KINGSTATE ELECTRONICS CORPORATION

PRODUCT CHANGE NOTICE:

We hereby announce that the part no.: KTG0912CL has been executed with a change. The updated product will be: KTG0912CL VERSION: TKS-5028-1.1

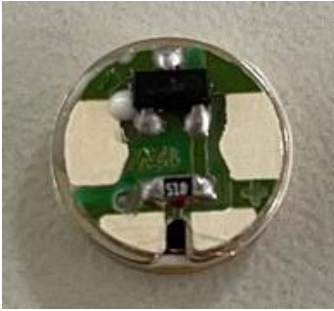
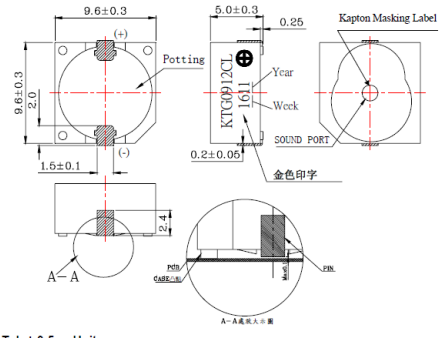
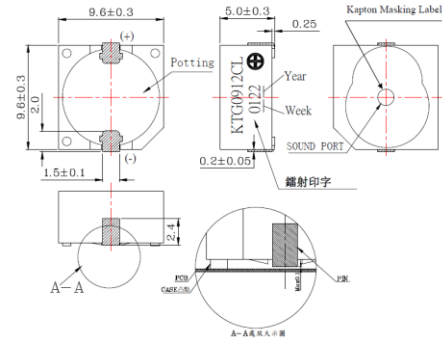
Change	Before	After
<p><u>外觀變更 Change of product appearance</u></p> <p>正面：新舊結構無差異</p> <p>Front: no difference between old and new structures</p>		
<p>側面：舊結構油墨印字，新結構鐳射印字，優點新結構鐳射印字更環保</p> <p>Side: old structure ink printing, new structure laser printing, Advantages New structure Laser printing is more environmentally friendly</p>		
<p>背面：舊結構環氧表面有兩個電子料痕跡；新結構環氧表面有一個電子料痕跡</p> <p>Back: There are two traces of electronic materials on the</p>

epoxy surface of the old structure; There is an electronic material mark on the epoxy surface of the new structure
